PIC-EL II Board B4 (4/17/06) Error and Rework Instructions

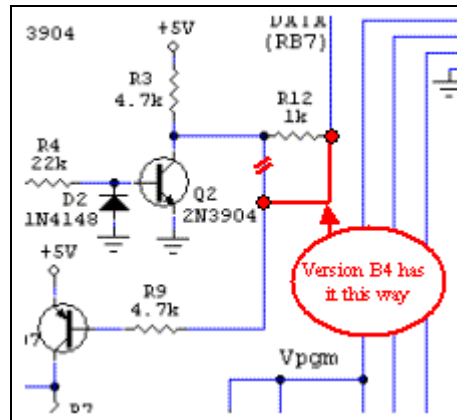
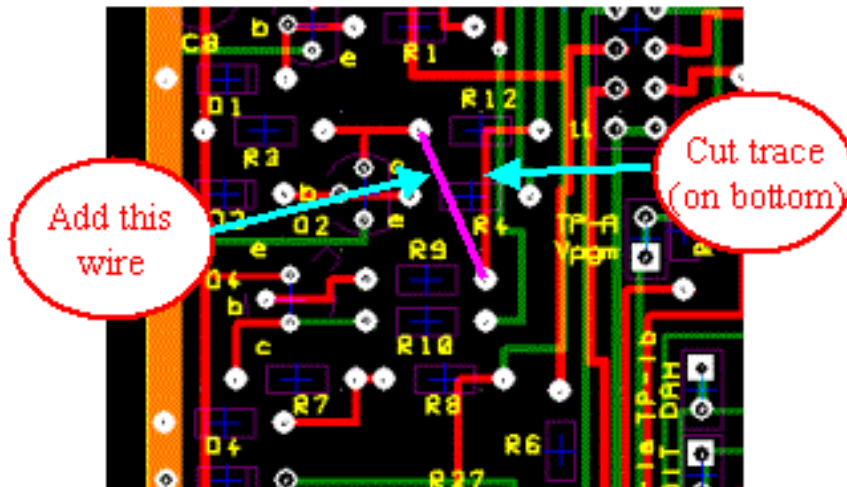
PIC-EL II Version B4 (4/17/06) has a minor error in a trace connection. The red wire in this diagram shows how it currently is. The wire from R9 to R12 should actually be connected to the Q2 side of R12.

If you want to modify your board to match the schematic you can cut one trace (on the bottom of the board) and add one jumper to fix it.
